**PRELIMINARY ENVIRONMENTAL  
NOISE REPORT**

PROPOSED INDUSTRIAL COMMERCIAL DEVELOPMENT  
9094 REGIONAL ROAD 25  
TOWN OF HALTON HILLS

PREPARED FOR  
Halton Hills One Limited Partnership  
c/o Rice Group

Updated April 10, 2026  
November 12, 2025  
File: 25-088

PLAN OF DEVELOPMENT  
SHOWING MINIMUM NOISE MITIGATION MEASURES  
FIGURE 2

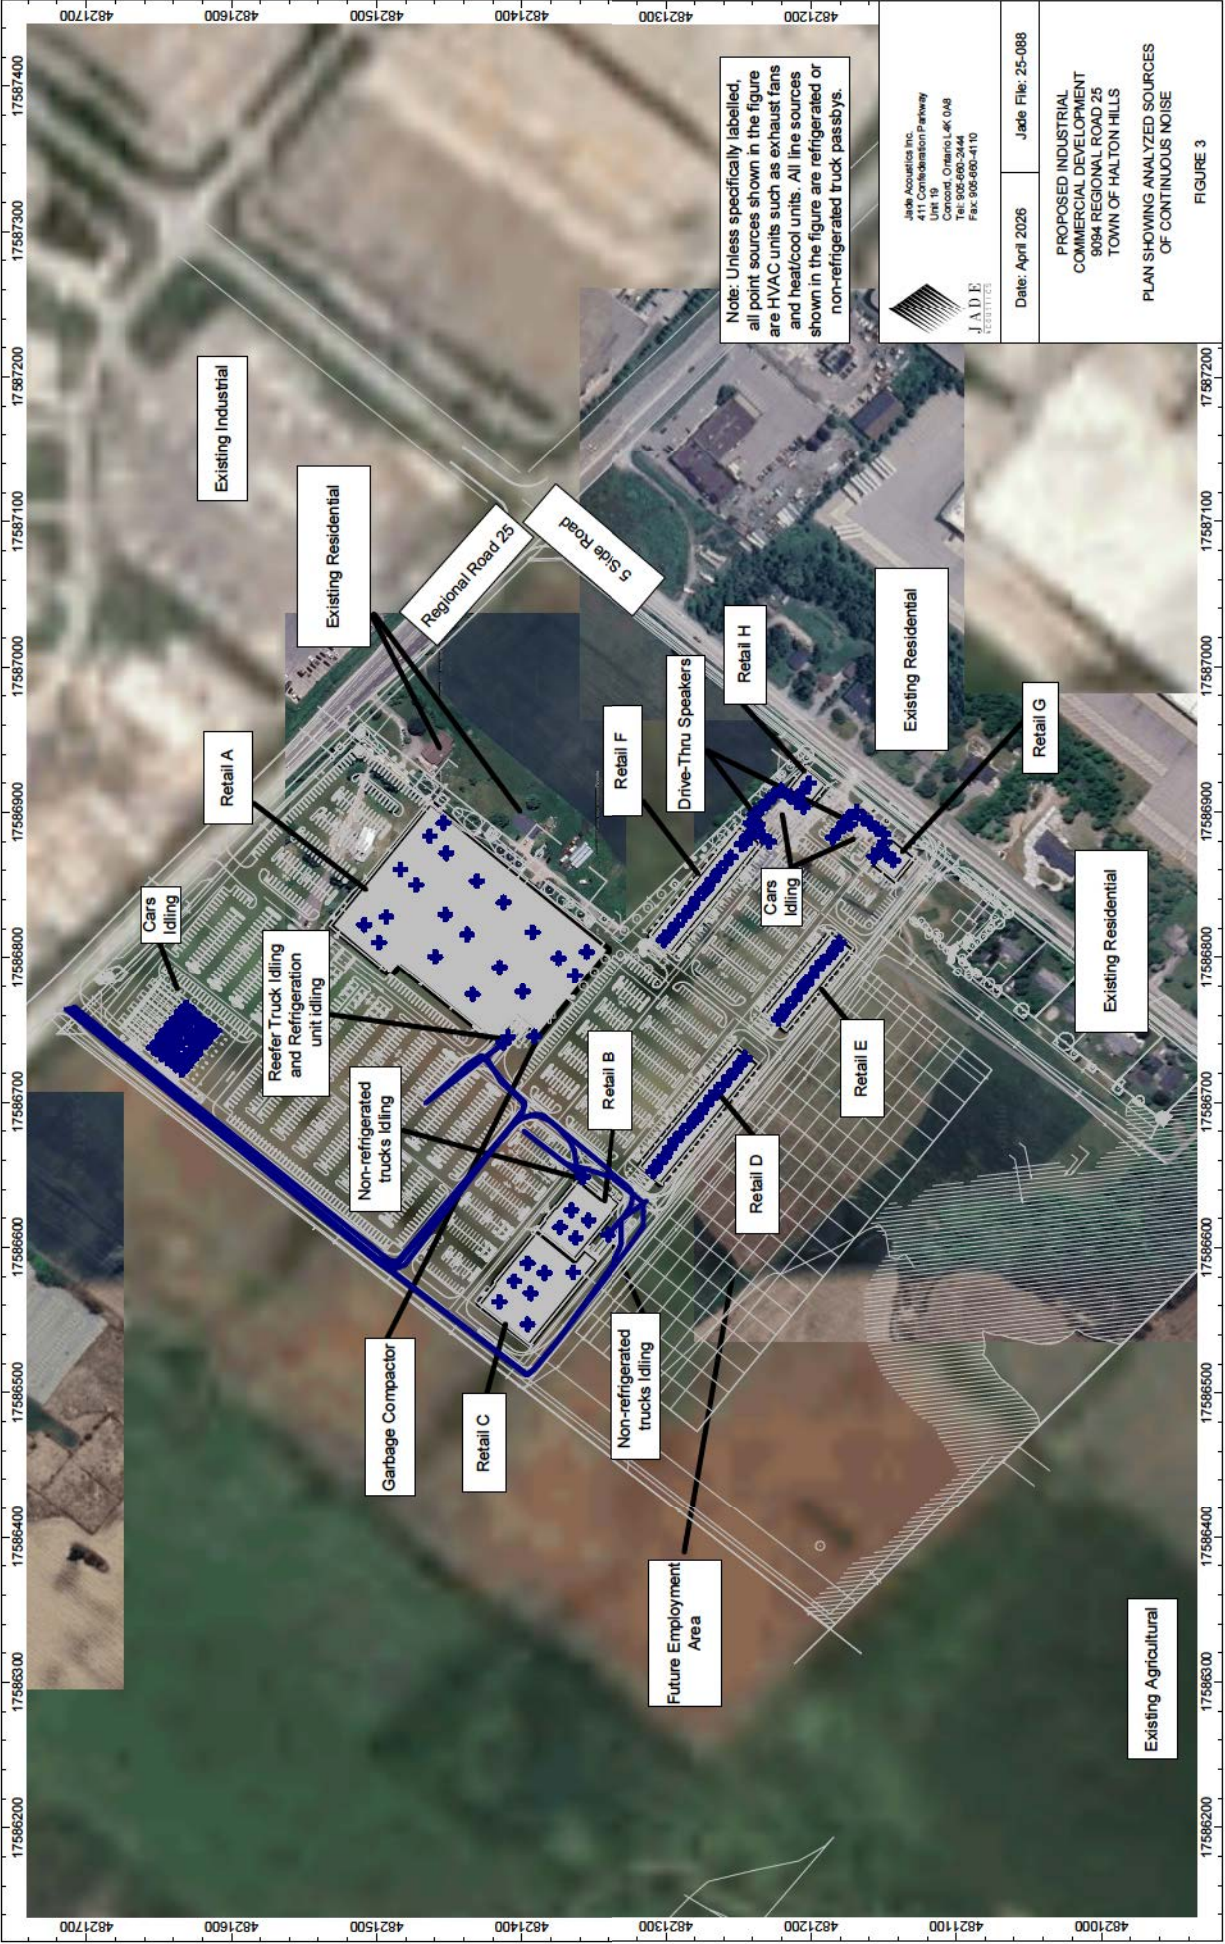
### **Comment #18 from Town of Halton Hills:**

*“The submitted Noise Impact Study prepared by Jade Acoustics, dated November 12, 2025, is considered preliminary and will be subject to revision based on the final Site Plan design. Development Engineering staff note that a more detailed review will be undertaken at the Site Plan stage to assess potential impacts of the development on surrounding properties. One key concern in the preliminary report is the absence of proposed mitigation measures in the area adjacent to the trailer and truck parking at Building D and the nearby residential properties. Given the proximity of these homes, it is unclear why truck idling was not anticipated or evaluated for this location. Development Engineering staff expect that this matter will be examined in greater detail at the Site Plan stage once the development layout is further refined, and that appropriate mitigation measures will be implemented as part of the Development.”*

### **Comment #19 from Town of Halton Hills:**

*“Section 2.0 Noise Sources of the Noise Study noted that Retail Block A is assumed to be a food store with vehicle repair operations. However, the submitted concept plan did not note down any repair operation/station for Retail Block A. All proposals and reports should be coordinated accordingly.”*

**Comment #20 from Town of Halton Hills:**

*“The MECP guideline NPC-300 permits higher maximum sound levels for stationary sources compared to Table 3 of the Town’s Noise By-law 2010-0030. The evaluation should apply the Town’s lower Class 2 rural limits to ensure a more conservative assessment. In addition, because the future tenants and operating characteristics of the warehouse and commercial buildings are not yet confirmed, hours of operation remain uncertain. To maintain a conservative approach, noise should be evaluated across all time-of-day periods: 07:00–19:00, 19:00–23:00, and 23:00–07:00.”*

- No coupling/uncoupling of tractor trailers within the proposed development;
- Installation of 1.5 m high roof parapets at some of the retail blocks (see Figure 2 for details); and

- A 2.0 m high acoustic barrier is to be installed west of Retail Block G and south of future employment area. The acoustic barrier should be installed along the entire rear property lines of the five (5) existing residential dwellings located on the north side of No. 5 Side Road in Milton. The barrier should continue along the rear property line of the heritage building and extend along the side property line. See figure 2 for details.

Figures 2, 7 and 8 show the location of the required at-grade and rooftop acoustic barriers as well as the administrative control. Tables 3 and 4 and Figures 7 and 8 show the predicted mitigated sound levels due to continuous and impulsive noise sources with the mitigation measures needed to achieve sound level limit.
